IN THE DRAWINGS

FIG. 10

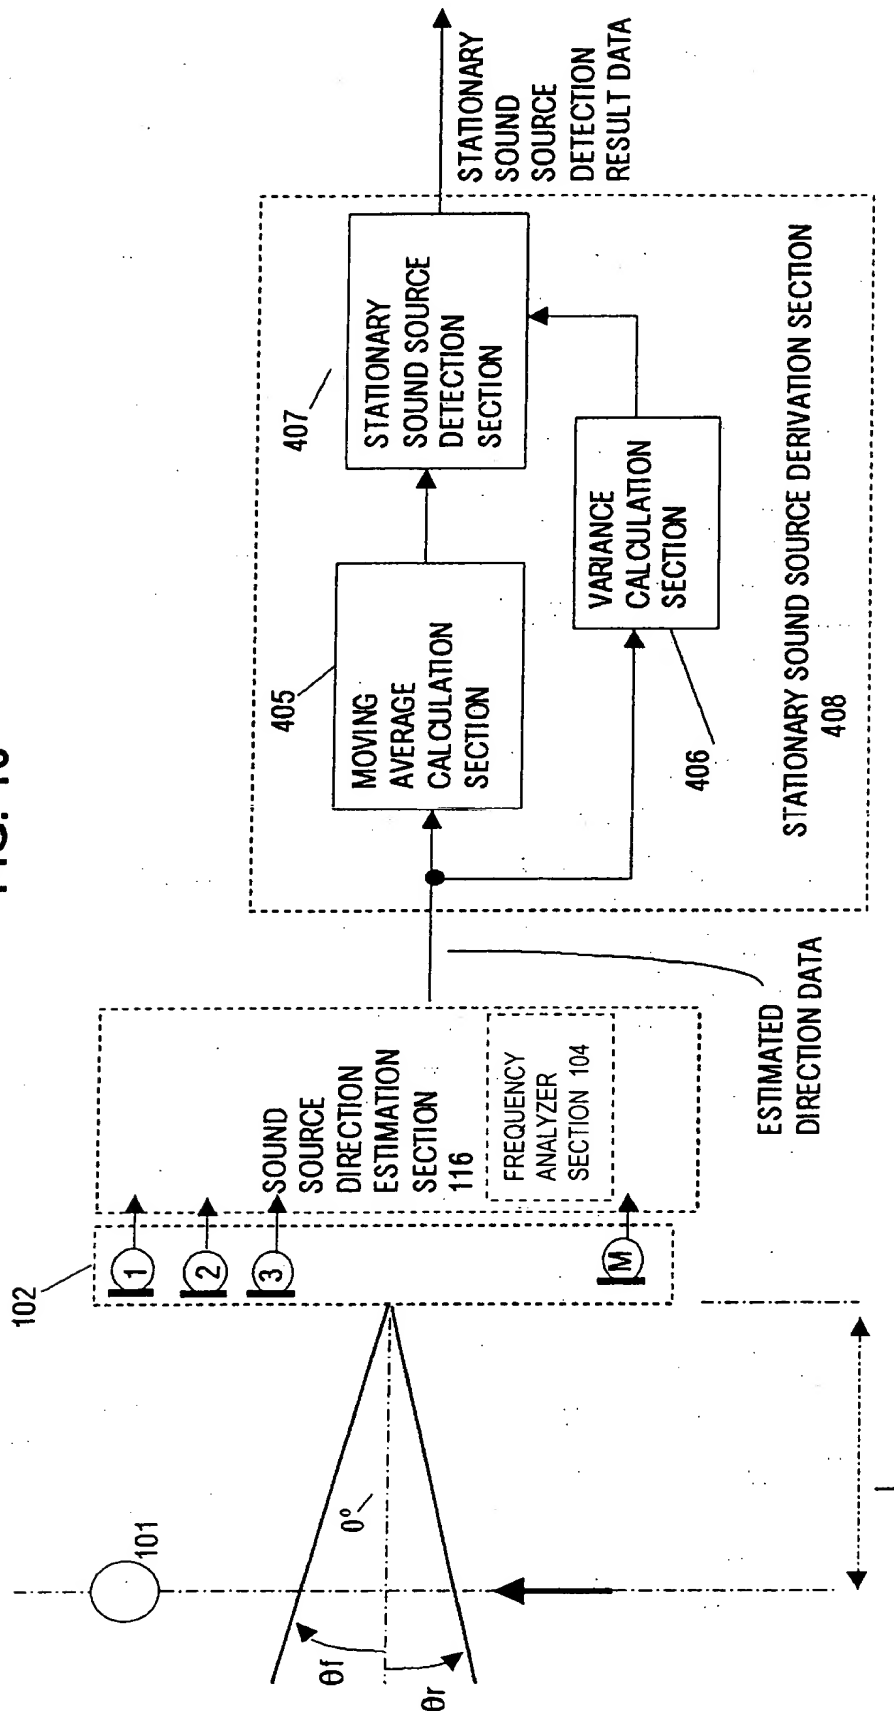
By separate letter to the draftsman, corrected drawings for Figures 6, 8, 10, 11, 13, 15, 17, 19, and 20 are submitted. The corrected drawings do not add new matter to the application. More specifically, the block labeled "frequency analyzer section 104" is added to each of Figure 6, 8, 10, 11, 13, 15, 17, 19, and 20 in conjunction with the sound source estimation section 116. As argued below, section 104 is described as being part of the sound source estimation section 116 shown in Figure 1, and, in fact, it is part of the aforementioned Figures. Therefore, the changes to these Figures do not introduce new matter into the specification.

FIG. 13

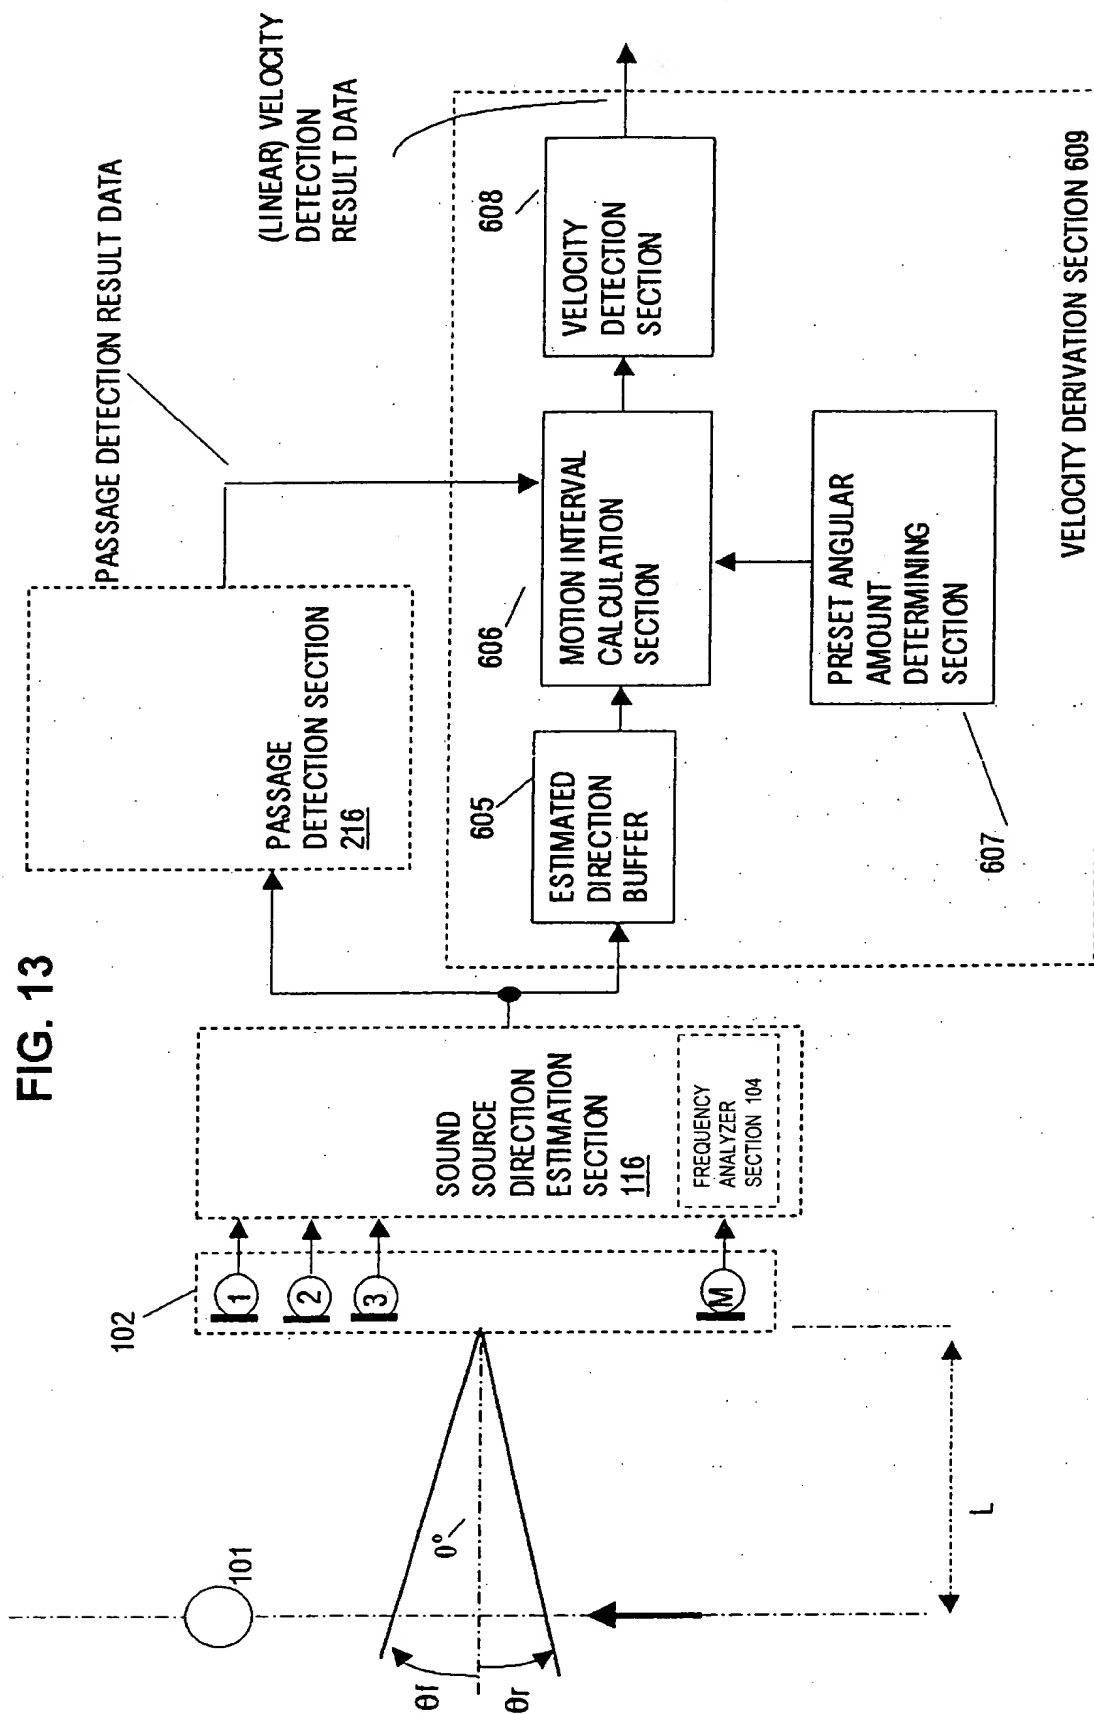
Applicants also question the objection to Species VI, and the allegation that the drawings do not depict a present angular amount determining section. Figure 13 of the drawings specifically identifies this claim feature as reference numeral 607, and the objection in this regard should be withdrawn.
